Access Compliance Report

Public Rights-of-Way

(Pedestrian Signals)

Intersection ID: N/A	Main Street:	Cross Street: N/A	Location: N/A
ADA ID: 4EF641158214	Signal Type: One Push Button-Non APS	Overall Compliance: No	Severity Score: BTN 1: N/A BTN 2: N/A No BTN: N/A
Codes/Mitigation Info/Possible Solution		Field Measurements/Component Compliance

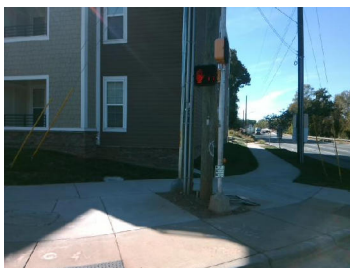
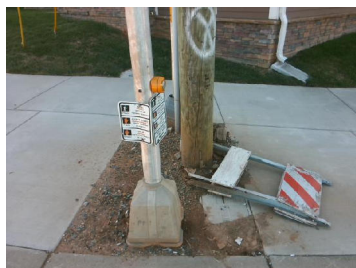
Possible Solutions: Remove and Replace Clear Space.

PROW/ADA: R209.1, TMUTCD 4e.08, R404.2, R406.2
